## **SE159:Class II Permissive Change Application**

**Model : SE159**

**FCC ID: OW7-SE159**

**2013-05-13**

## 2 PCB Comparison

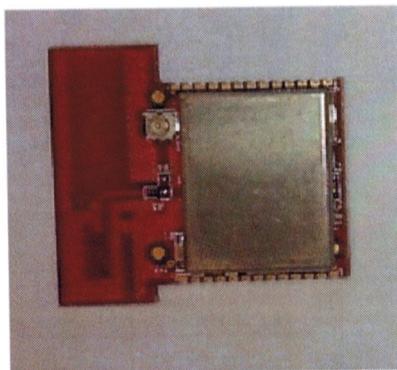
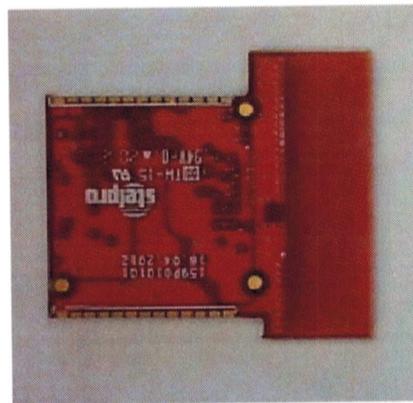
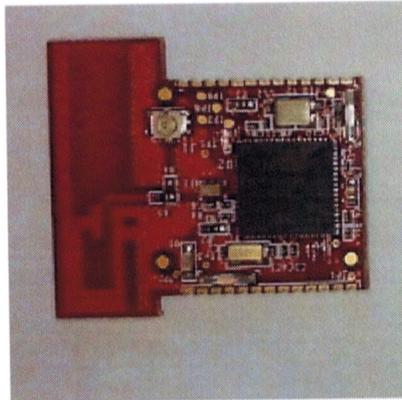
- We've changed the width of the antenna, it result in a decrease of the PCB width at the PCB antenna location
- We added a PI termination network for the PCB antenna.
